**Report: TAB Report**  
**Function: Test, Adjust, & Balance**  
**Date: 10/23/2025**  
**Completed By: National TAB**

**PROJECT**  
**03-09-26 QT #0588 OMAHA, NE**

# National TAB

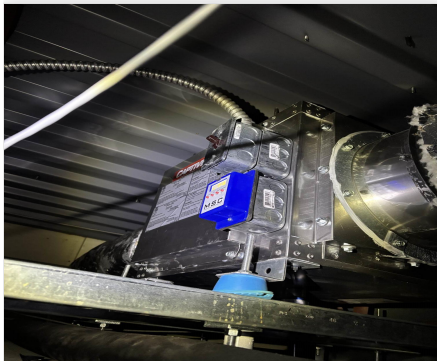
**Issue Name :** EF-2: Air Leakage  
**Description :** There is air leakage at the base of EF2. The inlet of the fan slightly overhangs the curb cap. This is affecting fan performance and efficiency. Recommend reworking curb or installing new curb cap to properly seal fan base.  
**Created By :** National TAB                      **Assigned To :** National TAB - Dan Hertenstein  
**Status :** Open  
**Priority :** High                                      **Asset Tag :** EF2  
**Originated Date :** 03/10/2026 - Kalen Kemp - National TAB

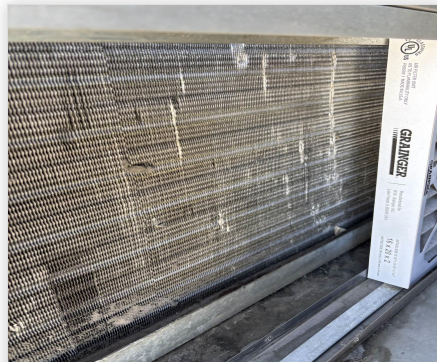
**Issue Name :** RT-1 and RT-2: Condenser Coil  
**Description :** The condenser coils for RT-1 and RT-2 are damaged. Recommend service.  
**Created By :** National TAB                      **Assigned To :** National TAB - Dan Hertenstein  
**Status :** Open  
**Priority :** **Medium**                                      **Asset Tag :**  
**Originated Date :** 03/11/2026 - Kalen Kemp - National TAB
